D5 SITE PLAN

SOLID WASTE DEPARTMENT APPROVAL PLAN - NOT FOR CONSTRUCTION
(CONTRACTOR NOTE: ELEMENTS OF THIS DRAWING ARE INCORPORATED IN SITE PLAN A001 WHICH IS TO BE USED FOR CONSTRUCTION)

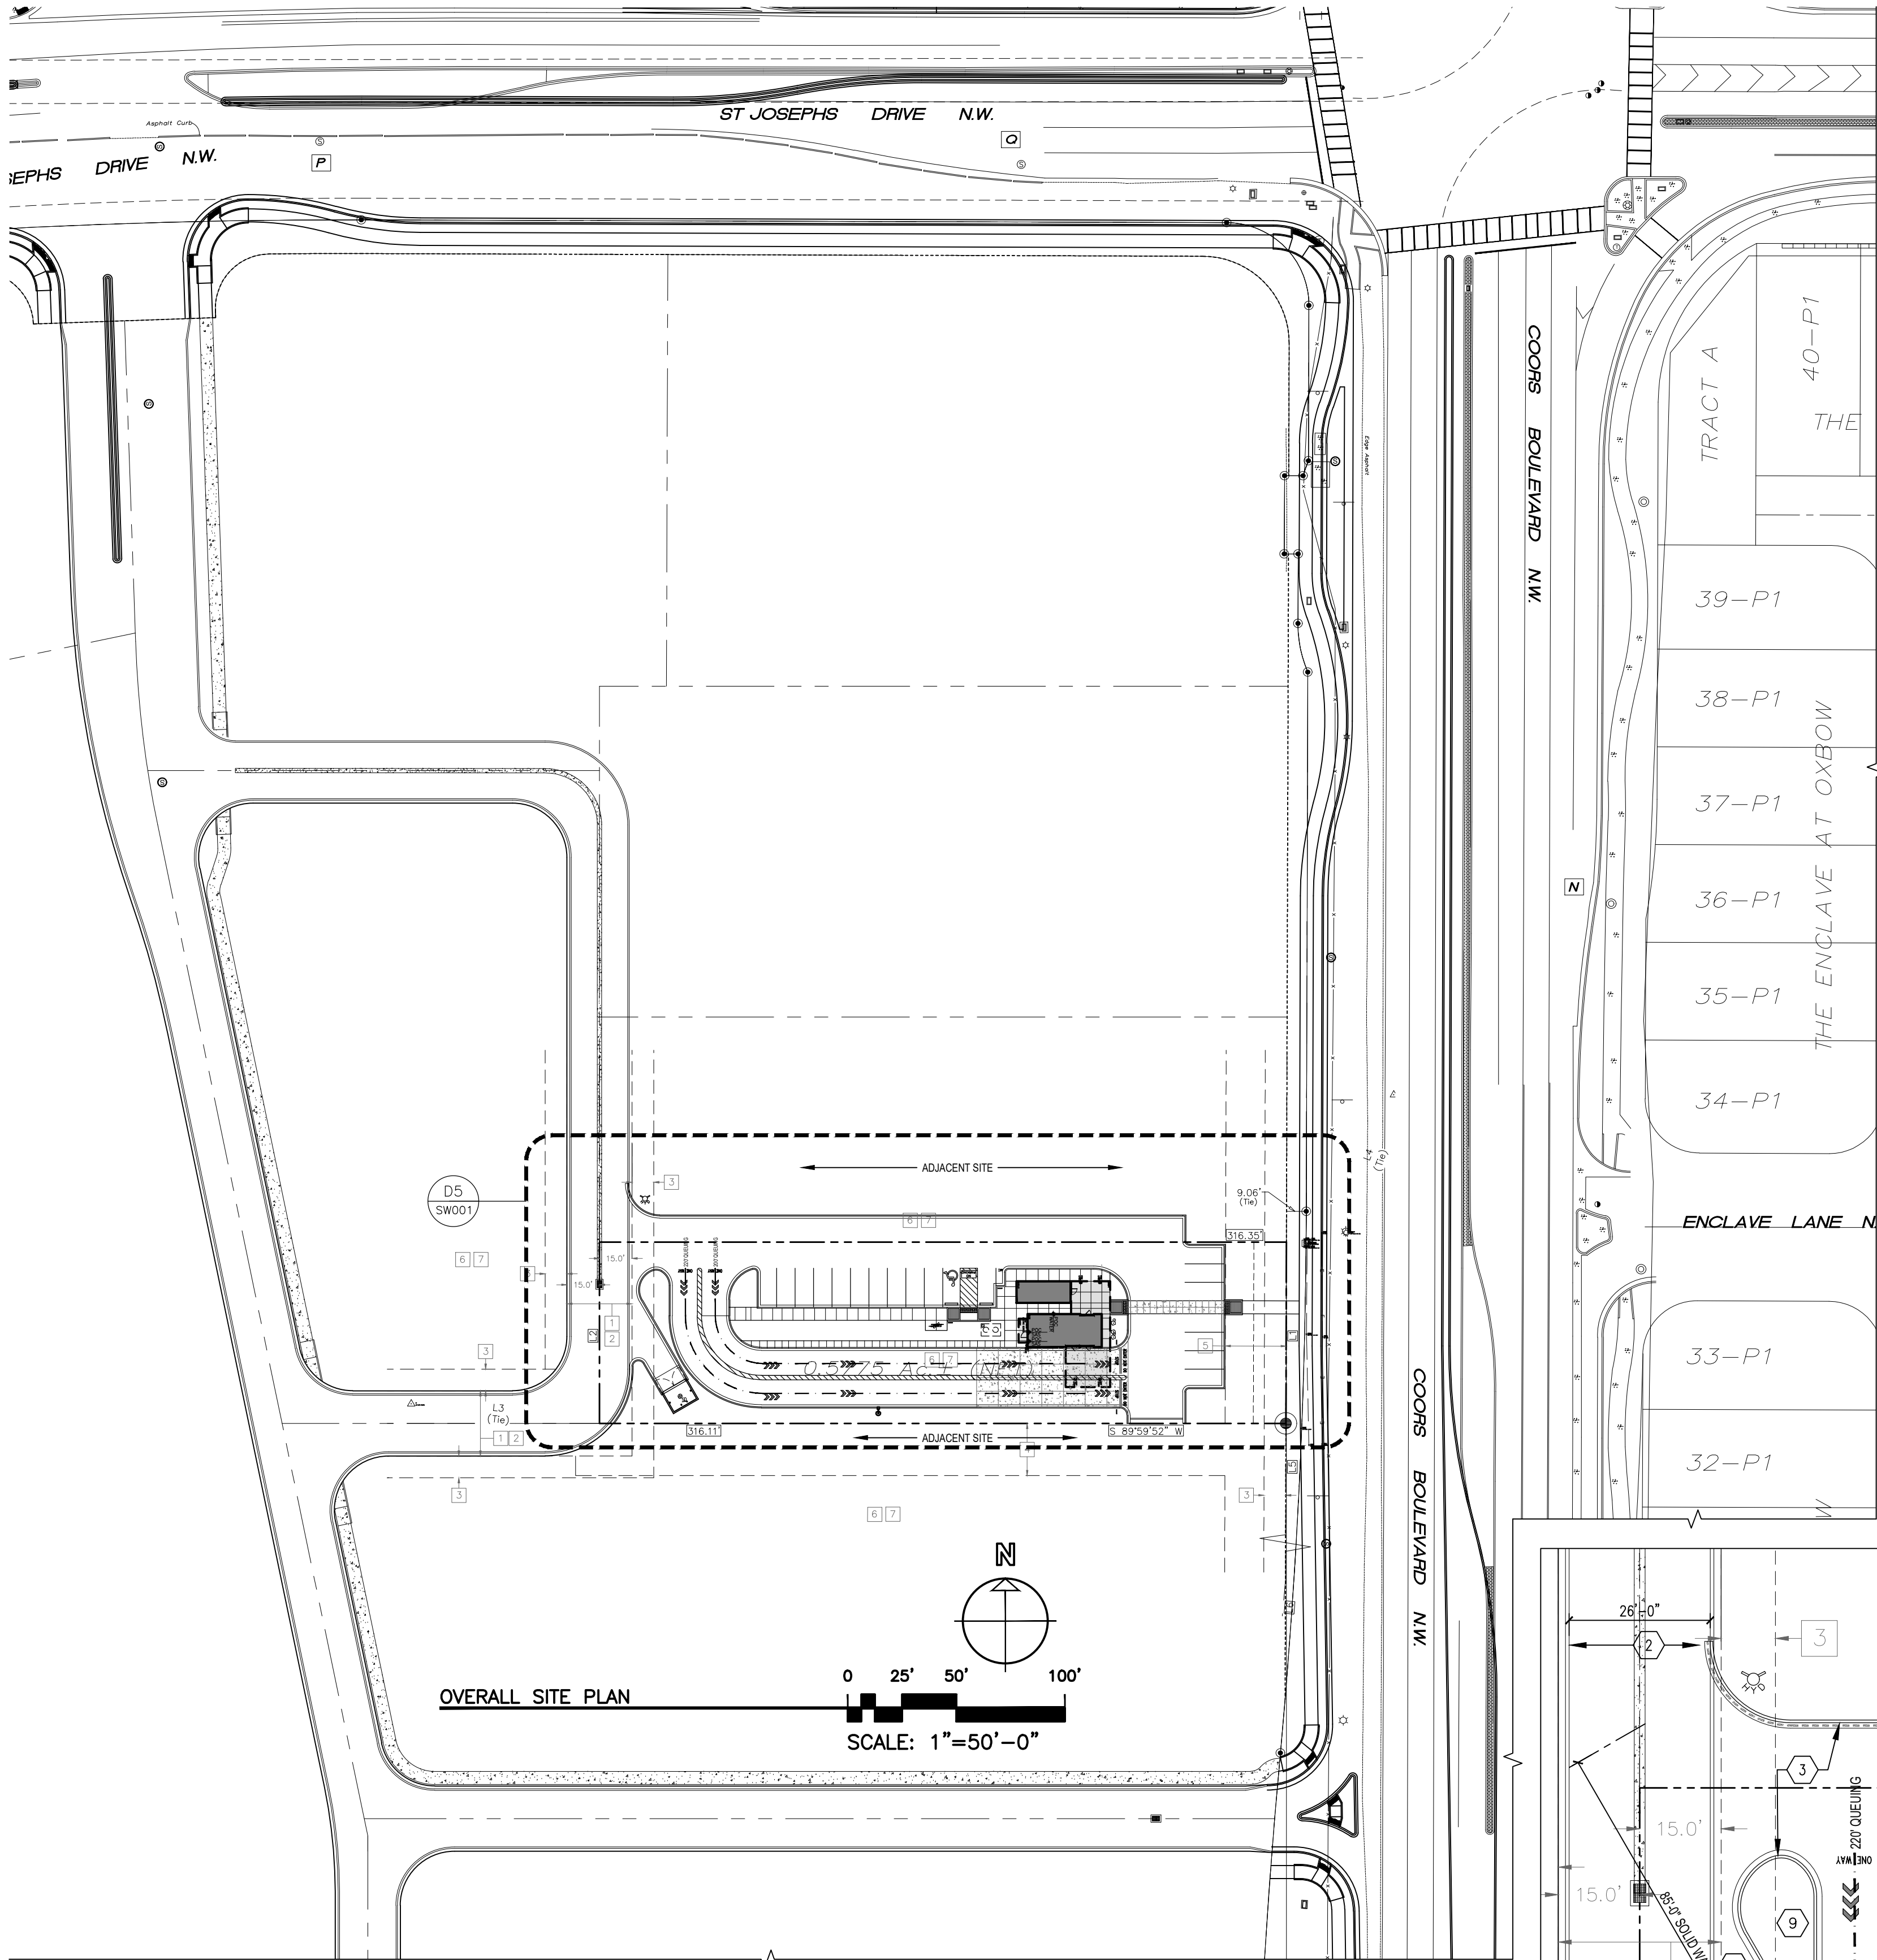
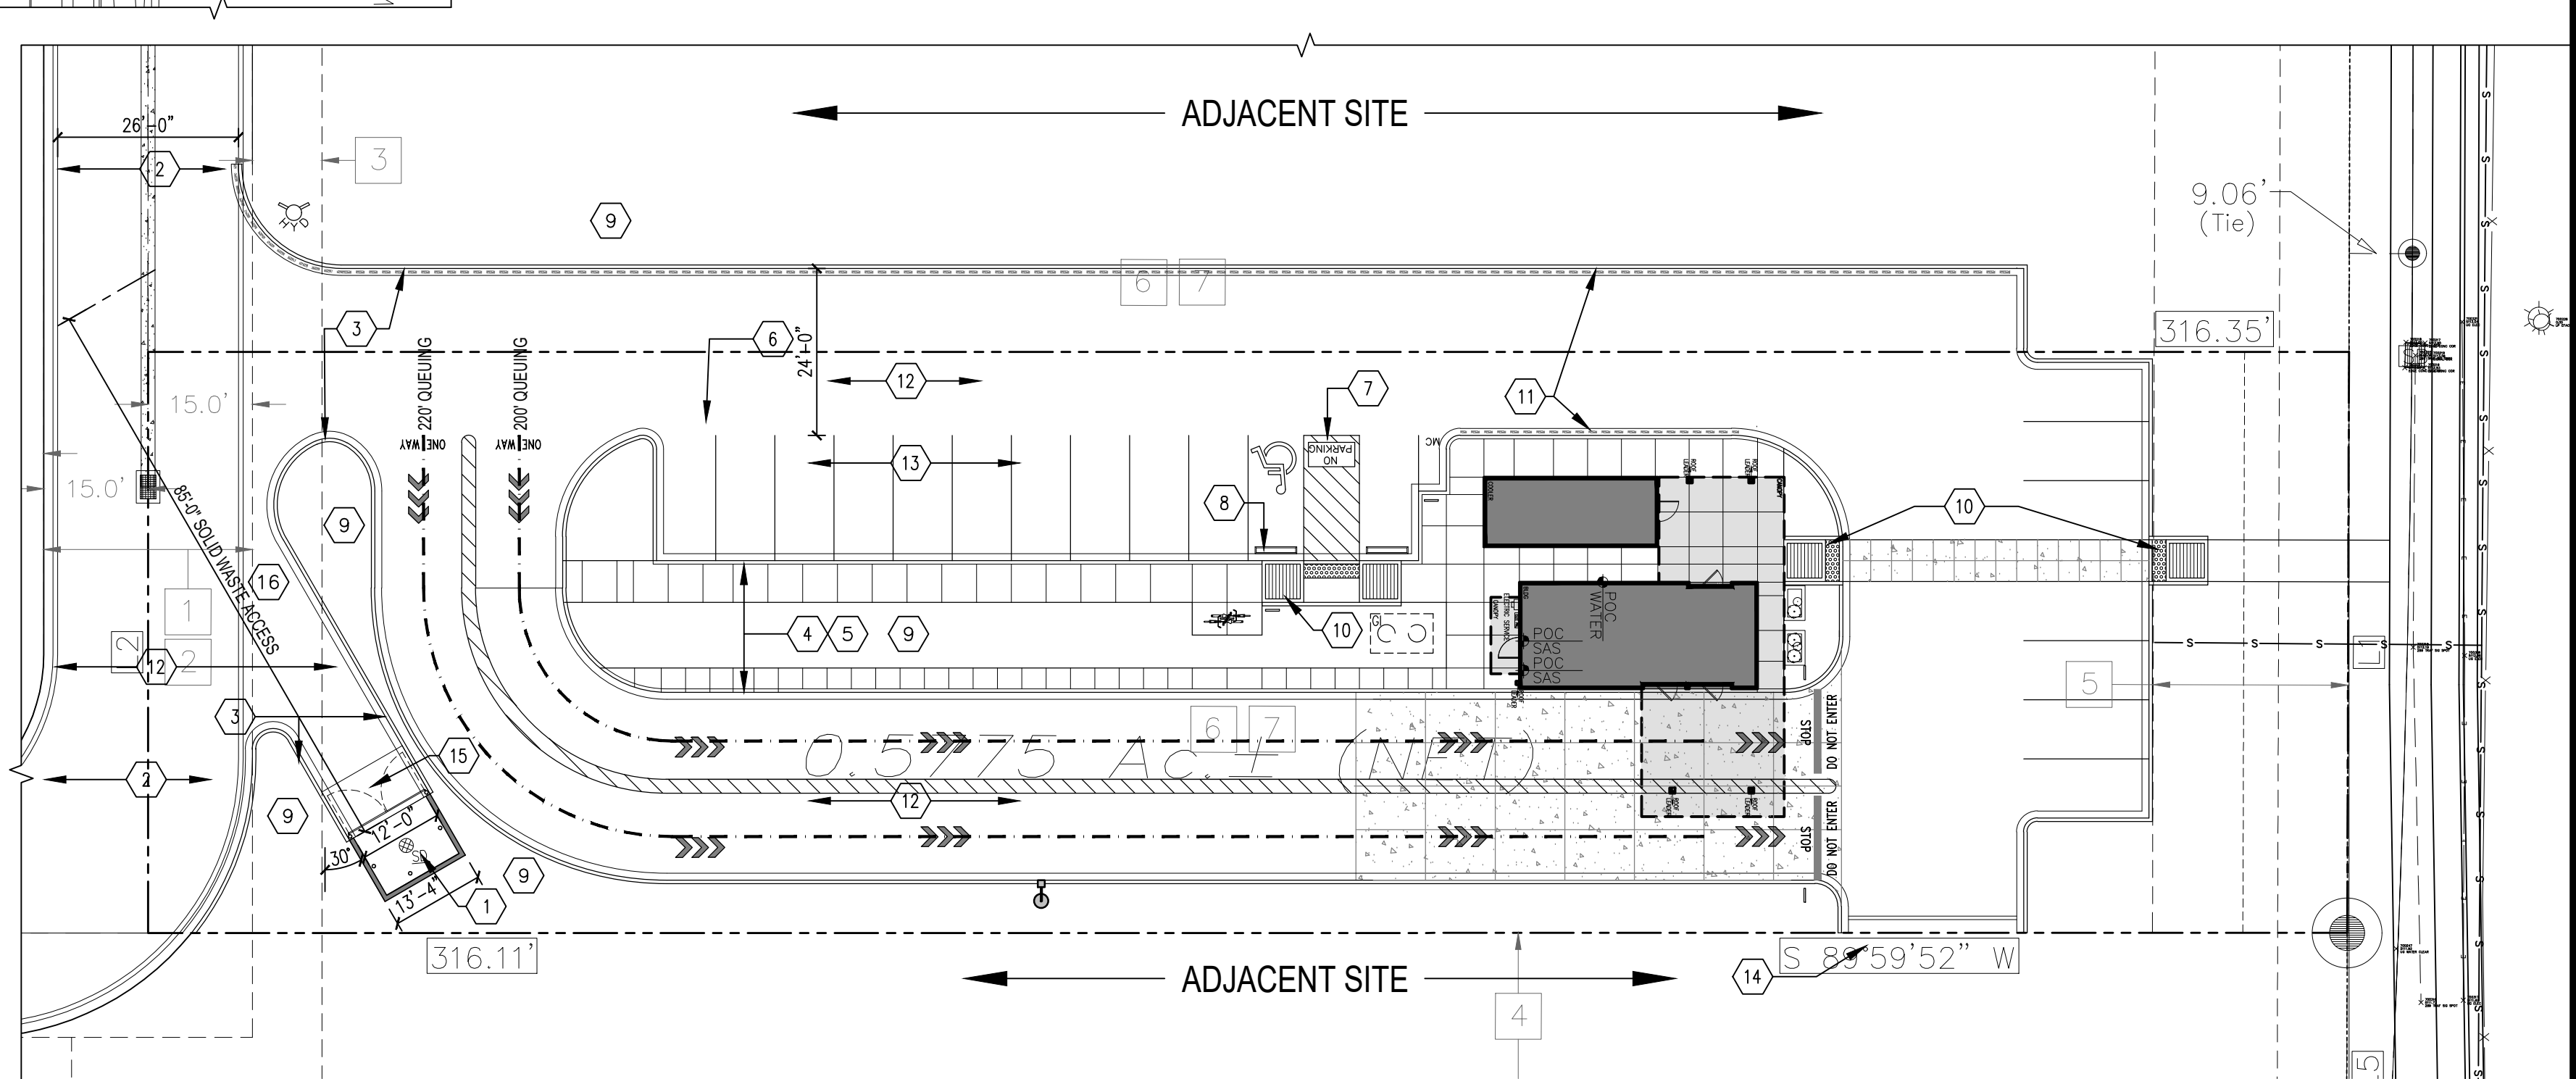
Approved for access by the Solid Waste Department.
All containers must be made accessible for pick up
between the hours of 5AM and 8PM.
Reviewer: Herman Gallagos
Date: 02-16-24
****Recycle Declined****
